# SERVICE BULLETIN

SB No. 99 Issue No. 4

**INSPECTION AND RECTIFICATION OF RUDDER PEDAL SLIDERS**

This issue 4 clarifies information previously given at Issue 3, ref paragraphs 4.3.2 and 4.4.2, rivet head below surface was .2mm now .8mm and .4mm respectively. Also adds alternative rivet ref para 4.4.3.

FIG 1

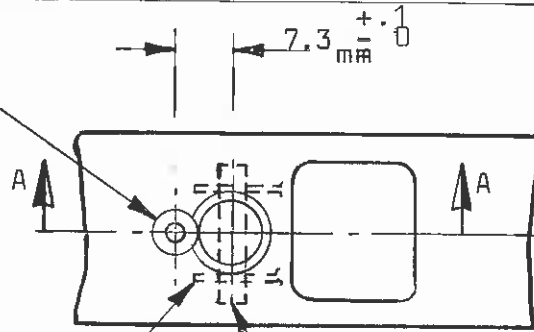
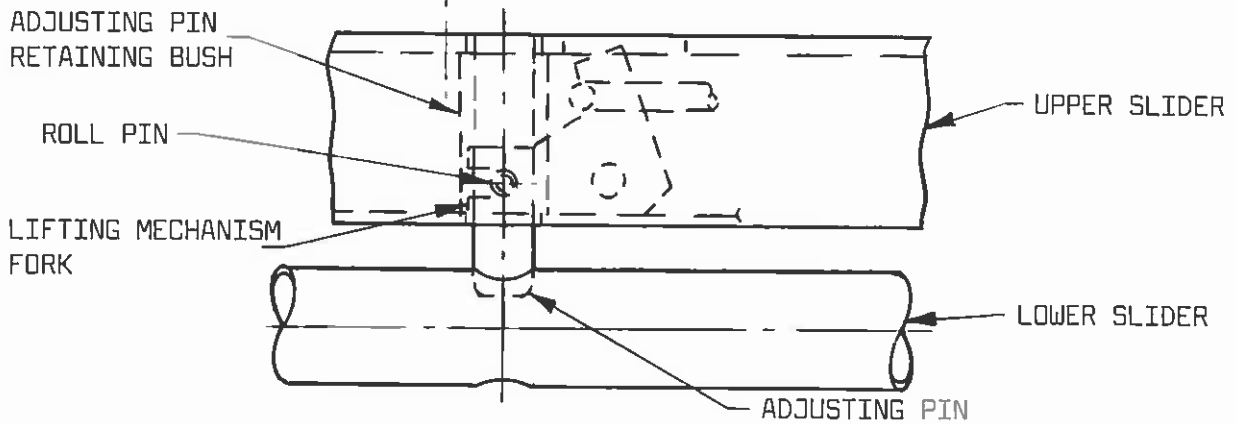
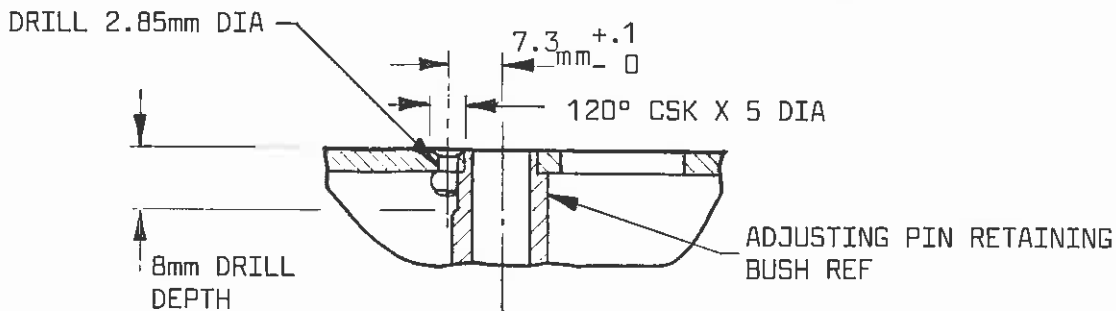
1. Remove each pedal/slider assembly and inspect for:
  - i) Correct operation of adjusting pin lifting mechanism, ie roll pin is engaged in fork, and for looseness of bush, ref Fig. 1.
  - ii) Check for any play in upper slider to lower slider attachment rivets, ref Fig. 2.

4. Modification Procedure:
  - 4.1 Remove pedal pad from slider mechanism.
  - 4.2 Addition of adjusting pin retaining bush anti turn rivet. Fig. 1.
    - 4.2.1 Ensure adjusting mechanism is aligned and is functioning correctly, with roll pin fully engaged in lifting mechanism fork.

- 4.2.2 Position jig JT67G-45-227 onto upper slider, jig will only fit correctly one way.
    - 4.2.3 Drill 2.85mm dia (No.33 drill) 8mm deep hole. Fig. 1, Section A-A.

- 4.2.4 Remove jig and csk 120° x 5mm dia.
    - 4.2.5 Using pop rivet gun fit pop rivet 126-24-031 (Tucker TLP/K319BS).
      - i) Ensure head is flush with surface of slider or up to a maximum of .2mm below surface.

- ii) Ensure adjusting pin and mechanism operate freely.

FIG 2  
UPPER SLIDER TO LOWER SLIDER, PEDAL MECHANISM JOINT

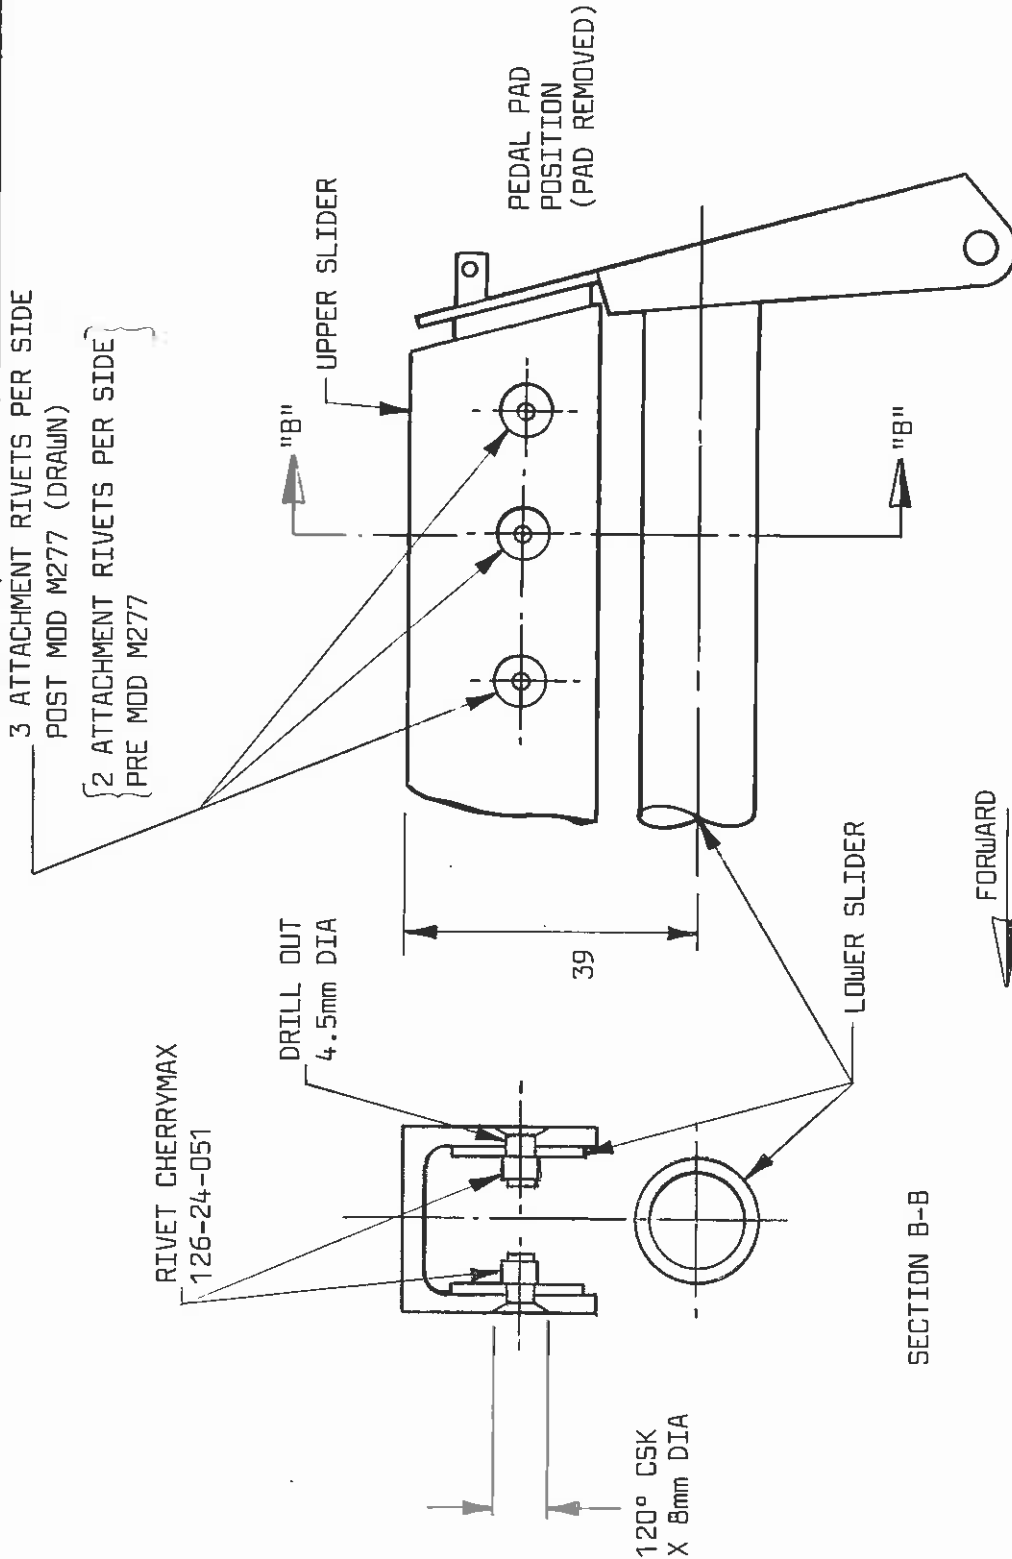
## 4.3 Upper slider to lower slider attachment rivets.

- 4.3.1 Drill out existing rivets using 4mm dia drill. Ensure drill does not penetrate too far into slider assy.

- 4.3.2 Drill hole out to 4.5mm dia oversize and csk 120° x 8mm dia (1mm deep).

Prior to rivetting ensure upper slider is parallel (Ref 39mm dimension) to and in line with lower slider, and that the rivet head will be flush or up to a maximum of .8mm below surface.

- 4.3.3 Rivet using suitable Cherry Max Rivet gun and rivet 126-24-051 (Cherry CR 3556P-5-3).

- 4.3.4 After rivetting check alignment and rivets for flushness. Rectify as necessary.

FIG 3

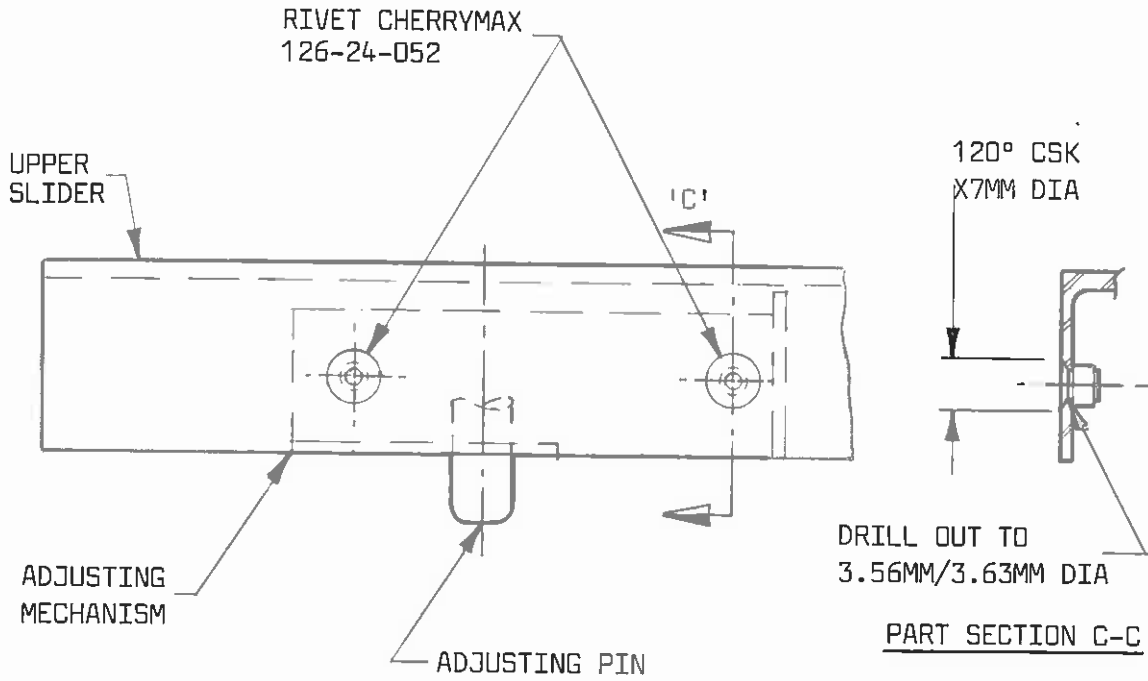
- iii) Check for any play in adjusting mechanism attachment rivets, ref Fig. 3.
2. If either i), ii) or iii) are found to be unsatisfactory, then modify pedals in accordance with paragraph 4.

## 4.4 Adjusting mechanism attachment rivets, ref Fig. 3.

4.4.1 Drill out existing rivets using 3mm dia drill. Ensure drill does not penetrate too far into slider assy.

4.4.2 Drill hole out to 3.6mm dia oversize and csk 120° x 7mm dia (1mm deep).

Prior to rivetting ensure mechanism (both fixed and moving) does not protrude below slider and that the rivet head will be flush or up to a maximum of .4mm below slider surface.

4.4.3 Rivet using suitable cherry max rivet gun and rivet 126-24-052 (Cherry CR3556-4-02 or acceptable alternative CR3556-4-02).

4.4.4 After rivetting, check correct functioning of mechanism, that mechanism does not foul nylon sliders and that rivets are flush ref note at paragraph 4.4.2.
